Planning Applications Committee

Wednesday 18th July 2018

ADDITIONAL INFORMATION

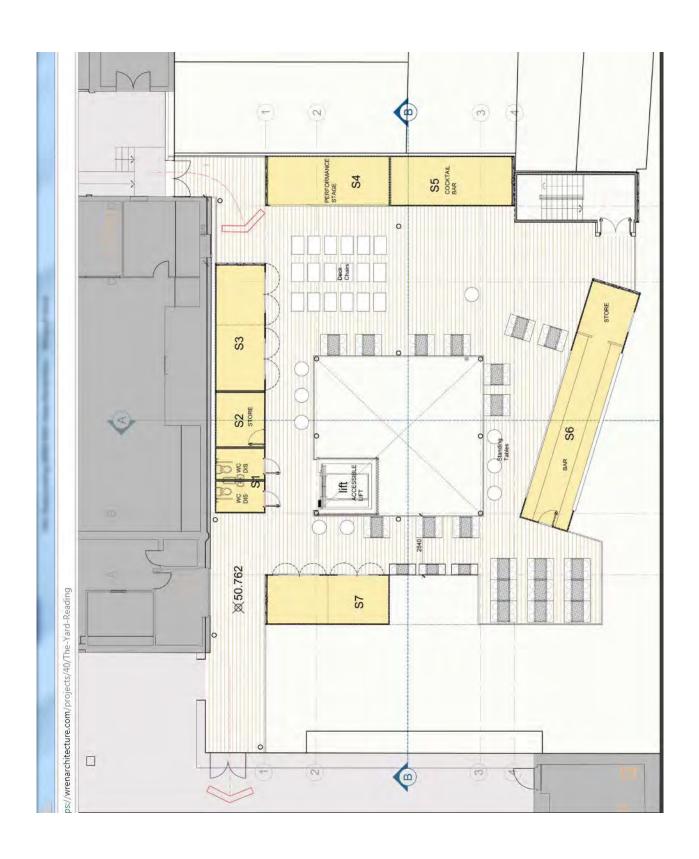
- 2.6 The applicant has asked that plans presented on the architect's website should not be relied on because they do not form part of the application. The plan below/overleaf is taken from the architect's website for 'The Yard'. Notwithstanding that it does not form part of the application, Members may wish to note the following.

- 2.7 Unit S2 appears very small (only 6.25 sq.m.) and officers question if this would be viable unit at all. The architect's website plan calls this a 'Store'. The applicant says that this would be a retail unit.

- 2.8 Unit S4 is labelled 'performance stage' and the 18 rectangles in front of it are labelled 'deck chairs'. The applicant is asking you to disregard this notation from the architect's website. Unit S5 is labelled 'cocktail bar' (12.5 sq.m.). There is a large clear space, some three times bigger than the unit itself in front of it. Again, you are being asked to ignore this.

- 2.9 Unit S6 on the submitted plans is a long bar (7.5m length) with the long side open to the north (to the roof terrace). The only intention of this unit would seem to be to serve drinks onto the terrace, as there is no area within the container(s) except the bar and the bar store. The architect's coloured CGI visualisation leads your officers to believe that the primary purpose of the terrace desk is as a performance/outdoor entertainment and bar space.

- 2.10 The CGI shows an over-counter window running across Unit S6 and then the open terrace sides either side, therefore the animation of the second floor being exposed to Hosier Street/Dusseldorf Way is of bars only. Stair 1 and Stair 2 allow easy by-passing of the retail areas, to access the roof terrace. In fact, if you were shopping on the ground floor and wanted to access the second floor on foot, you would have to physically exit the building to access either of the stair cores. This is further indication to officers that the second floor is a physically contained area and not a vibrant mix of local independent retailers and traders.
